SUFFOLK COUNTY PLANNING COMMISSION

AGENDA

STAFF REPORT

SECTIONS A14-14 THRU A14-25 OF THE SUFFOLK COUNTY ADMINISTRATIVE CODE

Site Plan

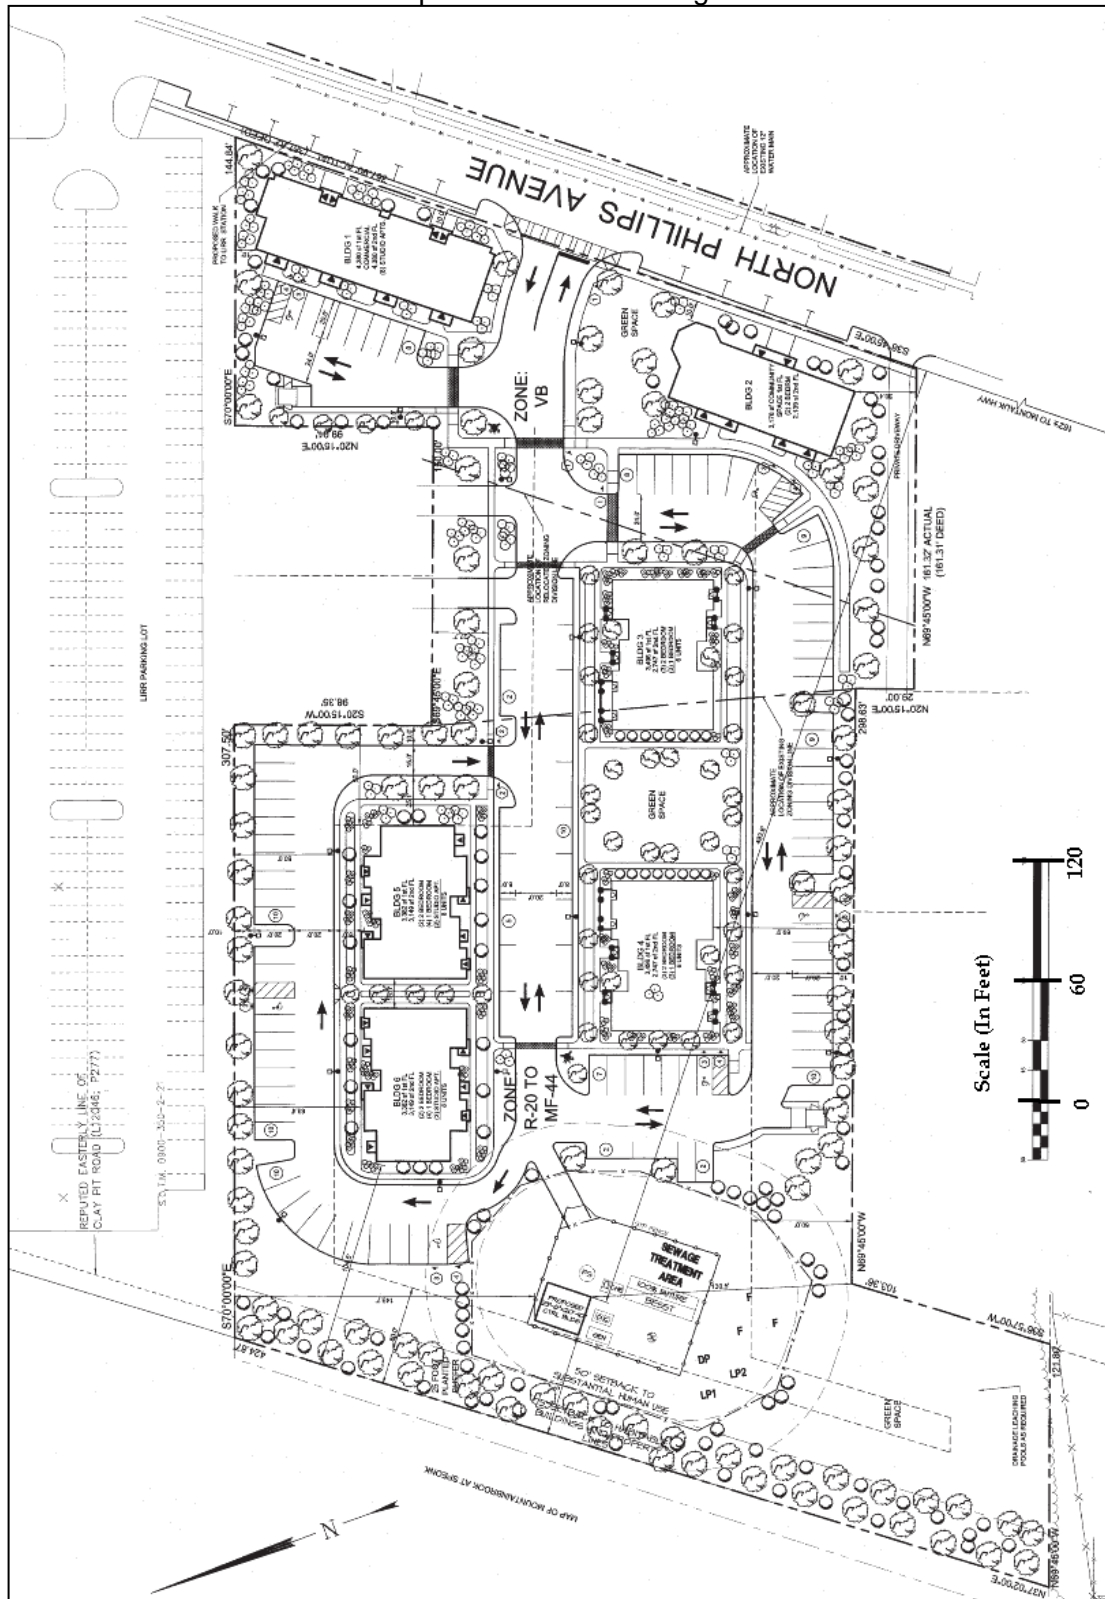
Storm water runoff from the proposed project will be retained on-site and recharged via a catch basins and leaching pools. It is the belief of staff that opportunities exist on site, during site plan stages to incorporate additional best management practices to the treatment of storm water runoff. The petitioners should be encouraged to review the Suffolk County Planning Commission publications *Creation of Man-made Ponds in Suffolk County* and *Managing Stormwater-Natural Vegetation and Green Methodologies* and incorporate into the proposal, where practical, design elements contained therein.

Little discussion is made in the petition to the Town and referred to the Commission on public safety and universal design. The applicant should review the Planning Commission guidelines particularly related to public safety and universal design and incorporate into the proposal, where practical, design elements contained therein.

4. The applicant should be encouraged to review the Suffolk County Planning Commission publication on Managing Stormwater-Natural Vegetation and Green Methodologies and incorporate into the proposal, where practical, design elements contained therein.

5. The applicant should be encouraged to review the Suffolk County Planning Commission Guidebook particularly with respect to energy efficiency and incorporate where practical, applicable elements contained therein.

6. The applicant should review the Planning Commission guidelines particularly related to public safety and incorporate into the proposal, where practical, design elements contained therein.

7. The applicant should review the Planning Commission guidelines particularly related to universal design and incorporate into the proposal, where practical, design elements contained therein.
